RECALL: This modification has top priority and must be performed immediately to ensure customer safety

Subject: Factory Direct Modification Campaign – Handlebar Clamp Replacement on all affected models listed below

**Affected 2011 Models: 450 EXC, 530 EXC and 690 Enduro R
2010 Models: 690 Enduro R**

Photo A

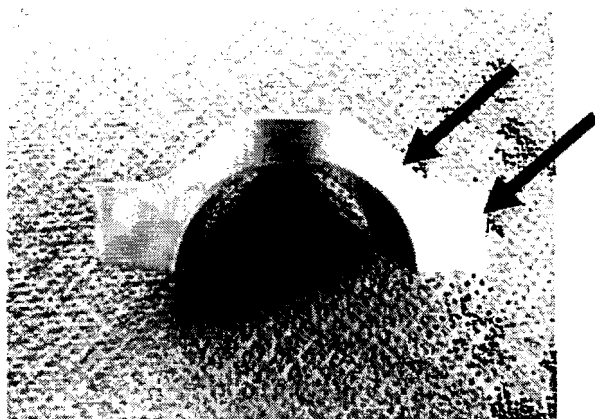
- » It has been determined that the cause of the defect is from variations in the material quality and the heat treatment process at the supplier of the handlebar clamps. To remedy this defect the replacement handlebar clamps are milled from billet material and have been reinforced in some areas. It is required that both handlebar clamps be replaced at the same time.

Photo A, part # 772 01 038 000, reinforced areas.

- » Replace the handlebar clamps with the new version, Part # **772 01 038 000**, on all vehicles that you have delivered to your customers and on vehicles in your inventory. Be sure to properly torque all four mounting bolts to 20Nm/14.8lbs.ft.

Photo B

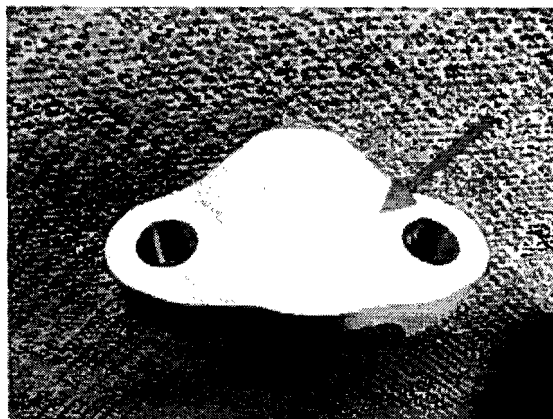
Photo B, handlebar clamp has a punch dot clearly marked to identify new part.

Carefully inspect each handlebar clamp (photo B) for the appropriate punch dot, as shown in the photo above. If the handlebar clamps have the appropriate punch dot the proper handlebar clamps are installed.
